CITY OF AUSTIN
Board of Adjustment/Sign Review Board
Decision Sheet

CASE NUMBER: C15-2014-0050

VARIANCE REQUESTED: The applicant has requested a variance from Section 25-2-779 (G) of Small Lot Single- Family Residential Use standards to decrease the rear through lot setback from 15 feet to 10 feet on the Waller Street property line; and from Section 25-2-779 (I) to decrease one of the interior side yard setbacks on each lot from 3.5 feet to 1 foot in order to construct a single family home and AC unit in an "CS-MU-CO-NCCD-NP", Commercial Services - Mixed Use - Conditional Overlay - Neighborhood Conservation Combining - Neighborhood Plan (lots 1-3) and "CS-MU-CO-NP", Commercial Services - Mixed Use - Conditional Overlay - Neighborhood Plan (lots 4-5) zoning district. (Central East Austin)

CITY OF AUSTIN – PLANNING AND DEVELOPMENT REVIEW DEPARTMENT
RESIDENTIAL PLAN REVIEW APPLICATION – MASTER COMMENT REPORT

Elevations
A104
CHECKED BY: SOLE 1/4" = 1'-0"

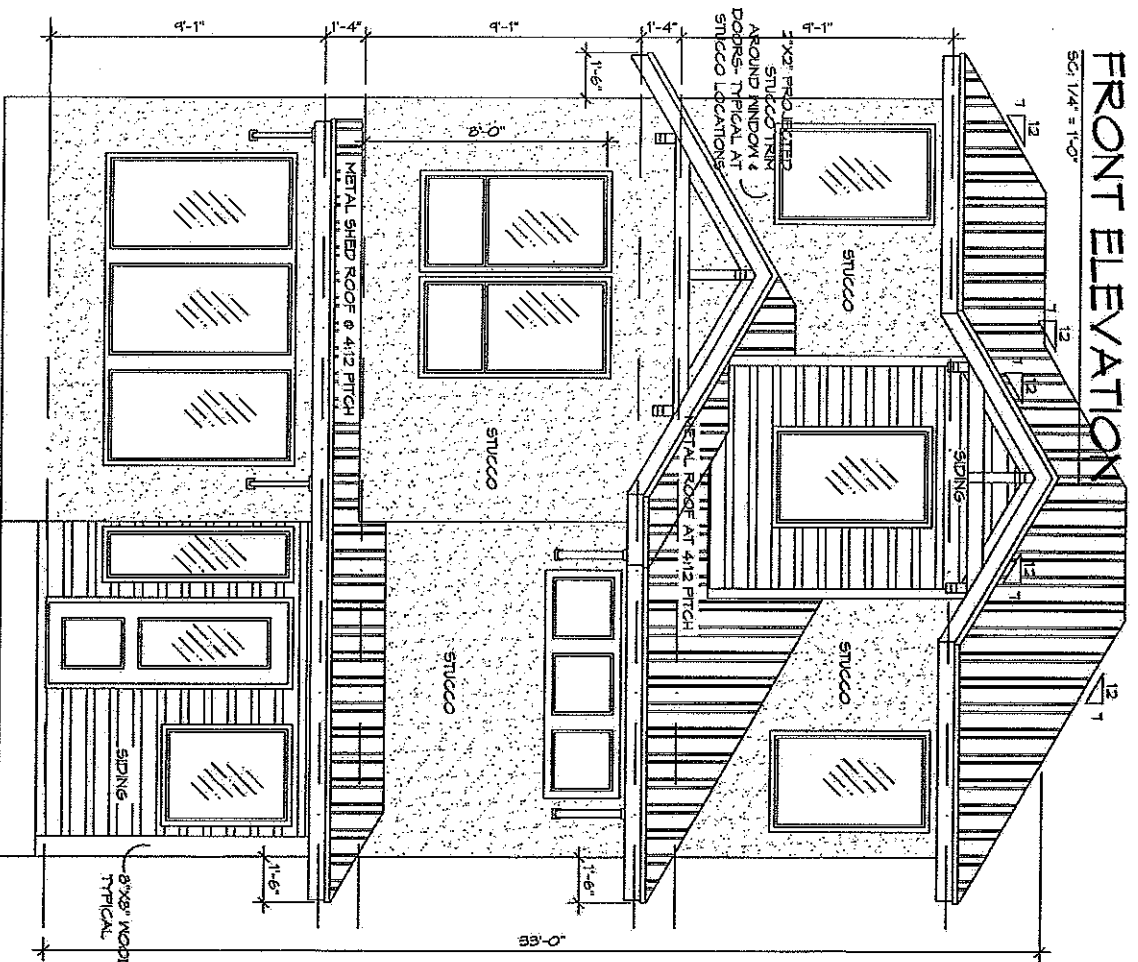
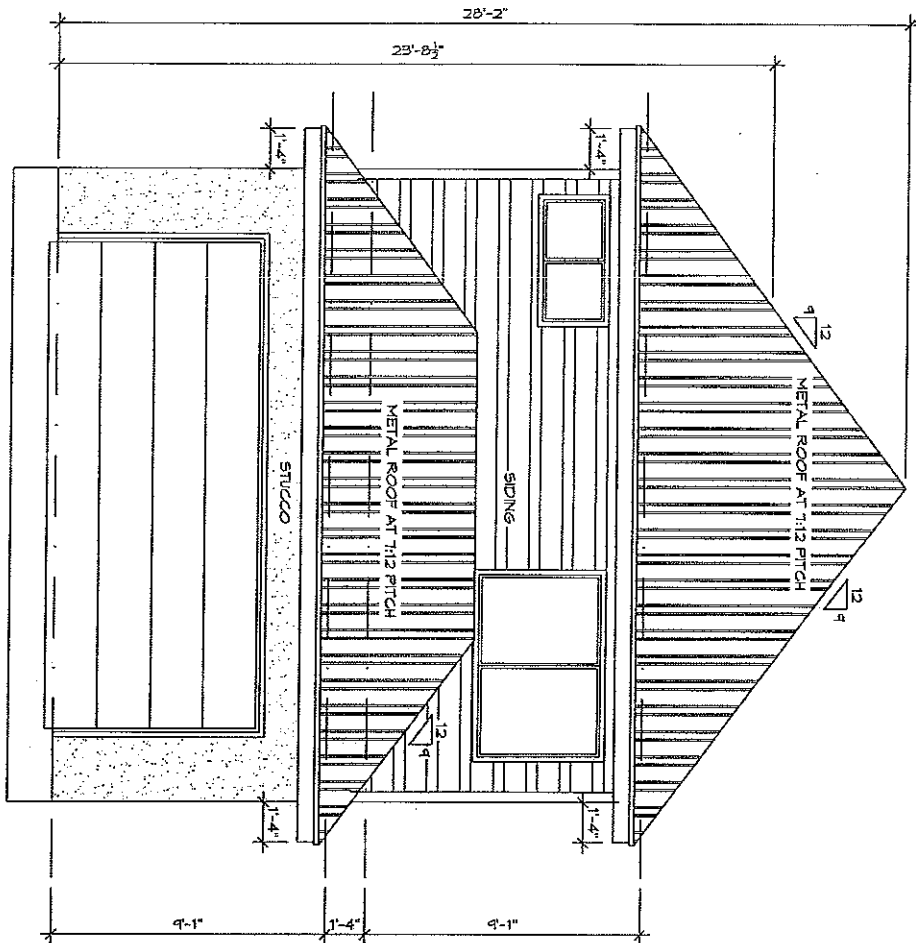
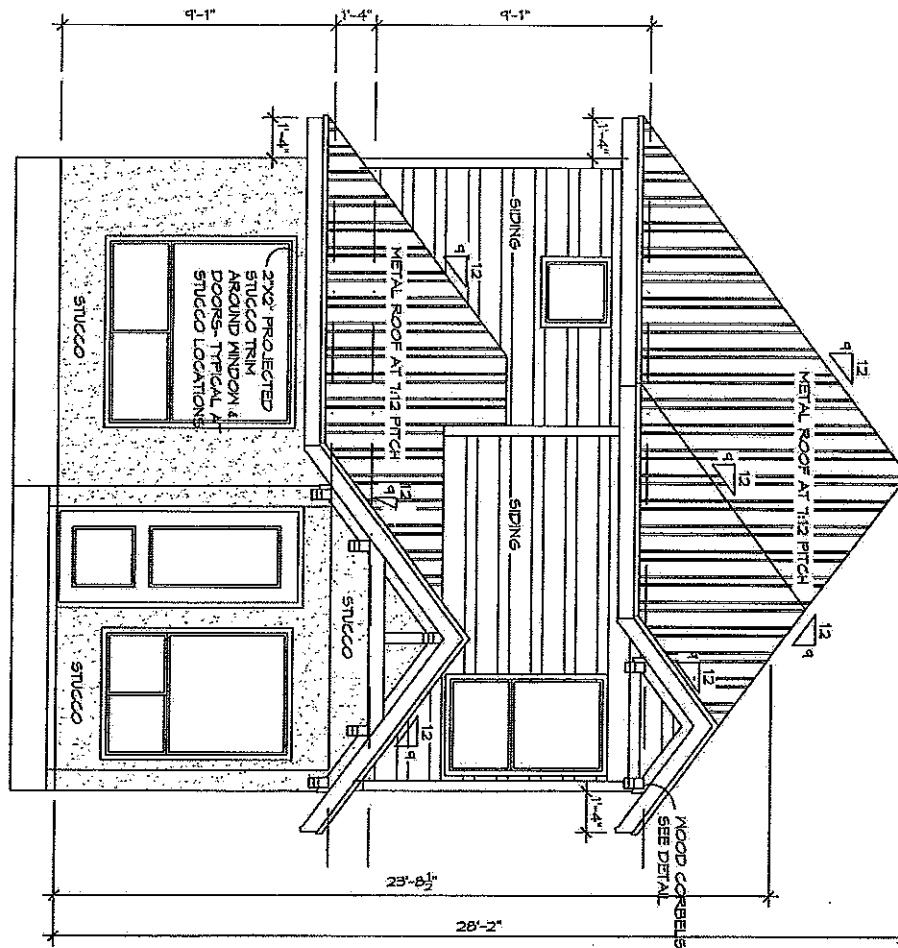
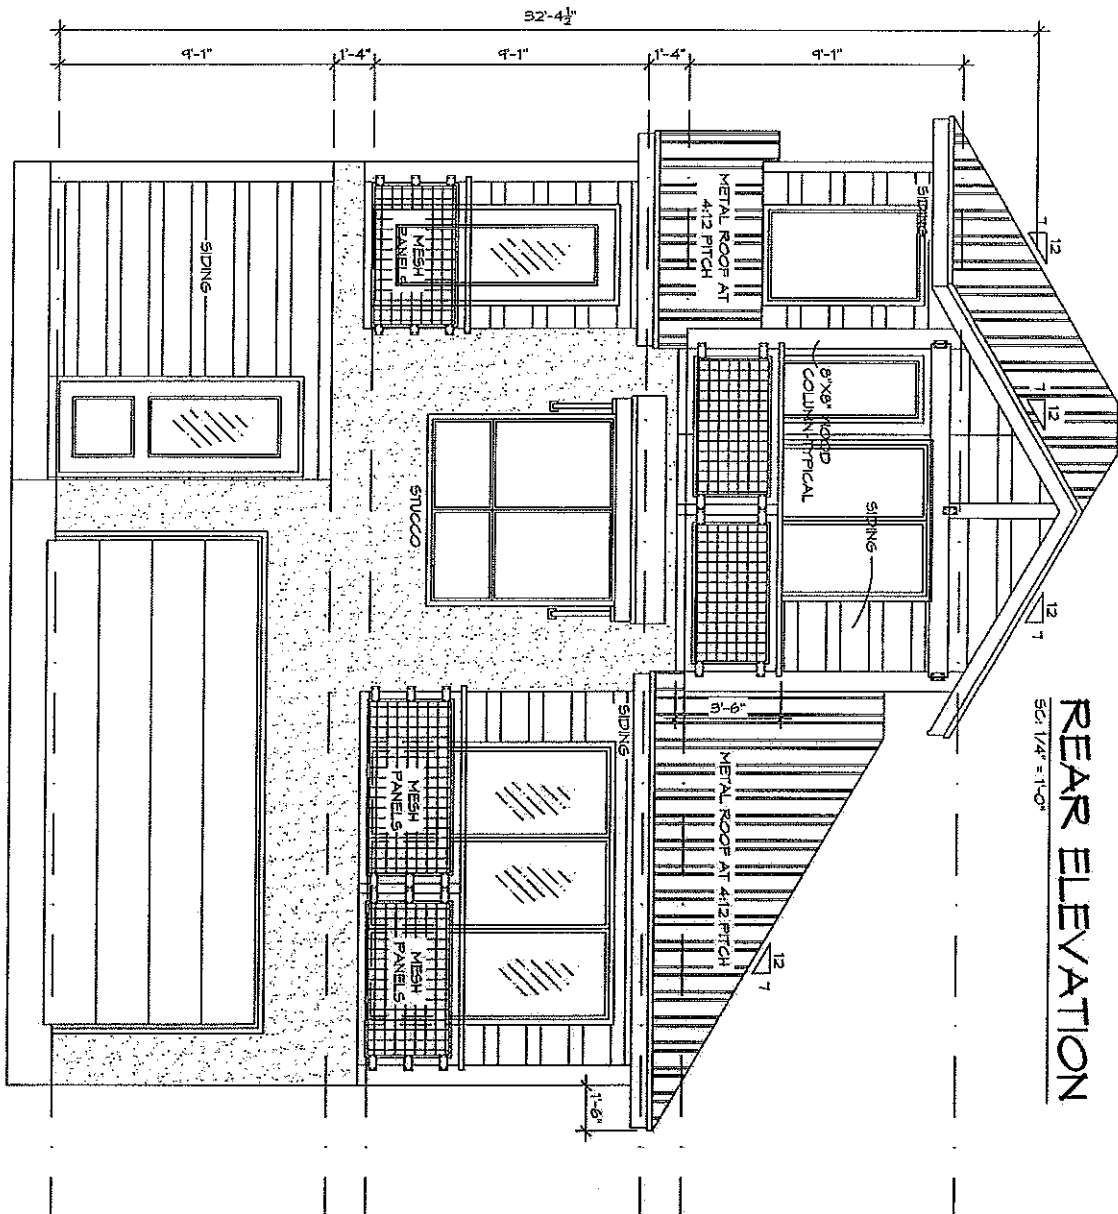
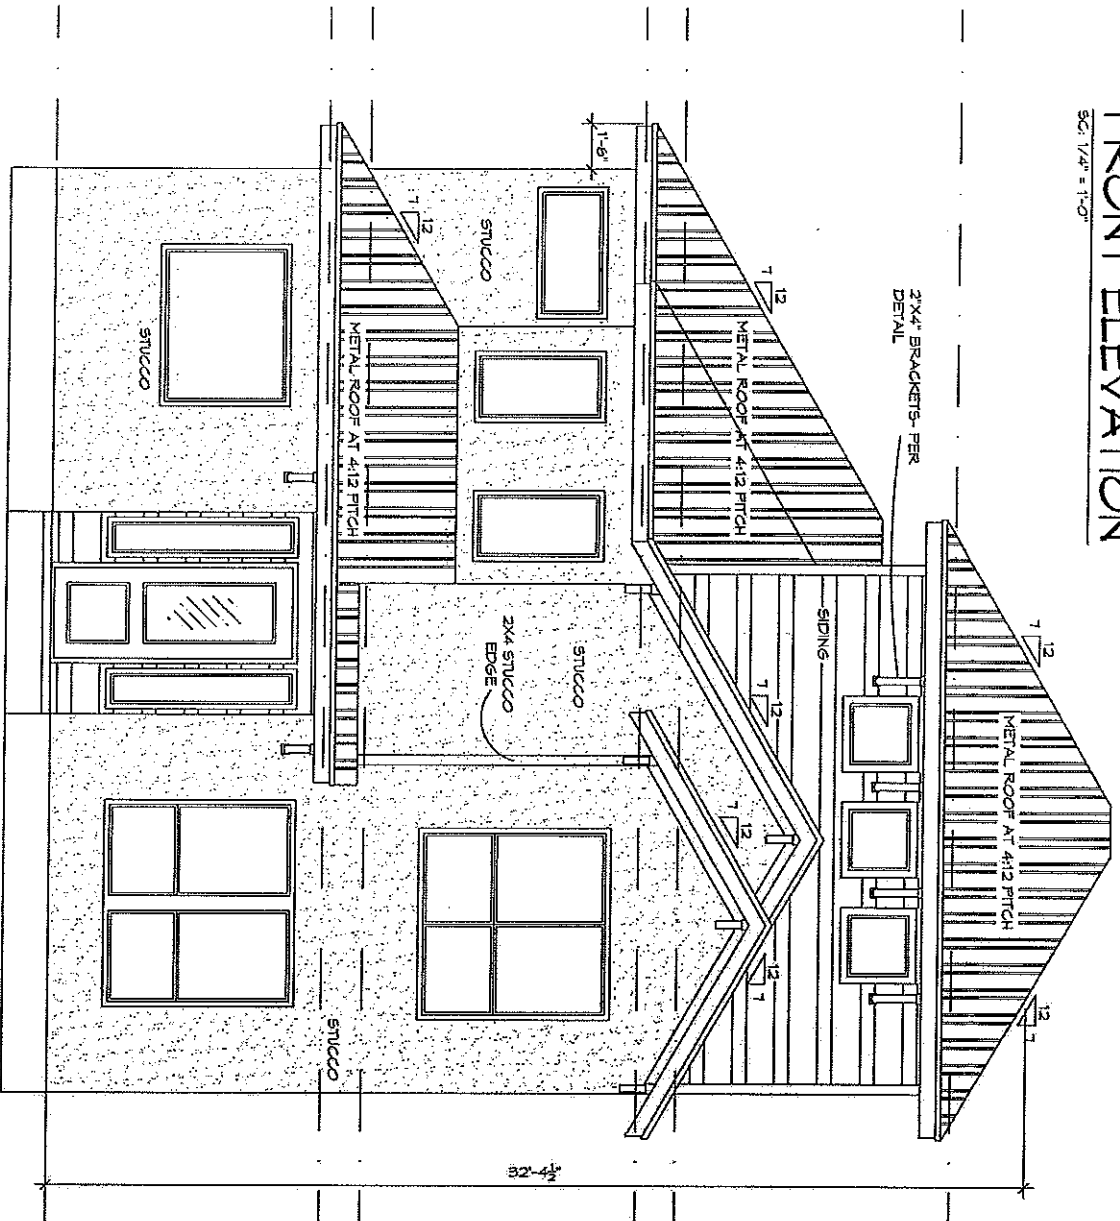
9. On at least one building elevation depict the structure's maximum height per LDC – 25-1-21-47. Note: Max. Bldg. Height is limited to 35 feet for this structure.

10. On the floor plans and the building elevations provide (label as FFE = ####.##) the finish floor elevations.
11. On the building elevations provide (label off to the side) the AAG value, FFEs values, top plate values, and the maximum height of the structure per 25-1-21-47 (on at least one of the building elevations).

- 3) Do you have any elevation sheets that we could add to the packet to show height, how the structures will look (not a requirement, but they may ask to see it and might save you a postponement). See attached the 3 different plans elevations

1191 Waller Street
(40' R.O.W.)

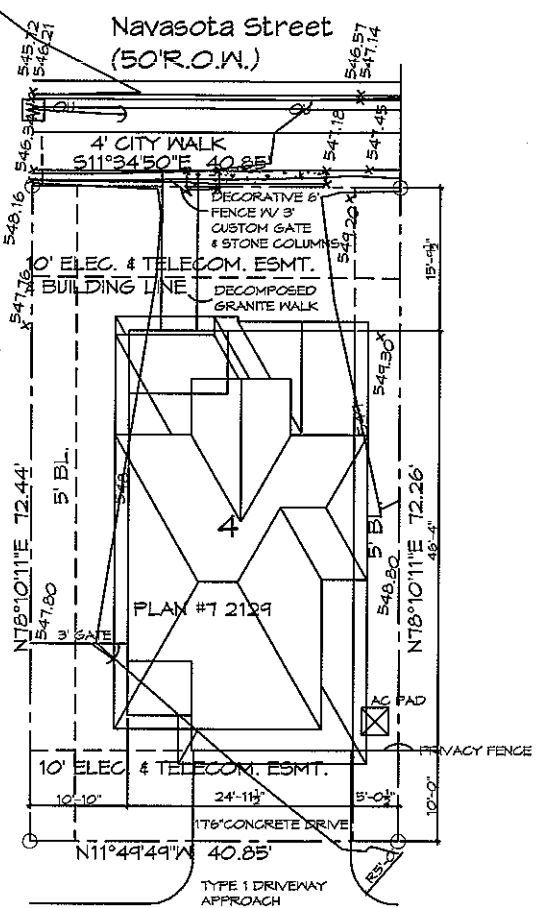
1. Subject property is a through lot and per LDC 25-2-515 – the rear yard setback is the same as the front yard setback. In addition, per LDC 25-1-21 (41) - a front line for a through lot is the lot line abutting the street that provides the primary access to the lot. The setbacks for this property are 15 feet for both the front and rear yard setbacks, 10 feet for a street side yard setback, and 5 feet an interior side yard setback.

3. The plot plan submitted and proposed building footprint does not comply with the required setbacks for this property. The garage is encroaching into the front yard setback. Plans will have to be revised or the applicant must seek a Board of Adjustment Variance. 25-2-779

4. The property has multiple 10 feet easement (electric and telecom) lines along the property lines adjacent to the adjacent Right-of-Ways. The plot plan must be revised to correctly depict and label the existing 10 feet easements as platted and recorded with the Anderson Hill Subdivision.

5. No encroachments of structures (which includes eaves and roof overhangs) are allowed within the 10 feet (electric and telecom) easements on the subject property. Plans must be revised and approved by Austin Energy prior to Final Approval of this Plan Review.
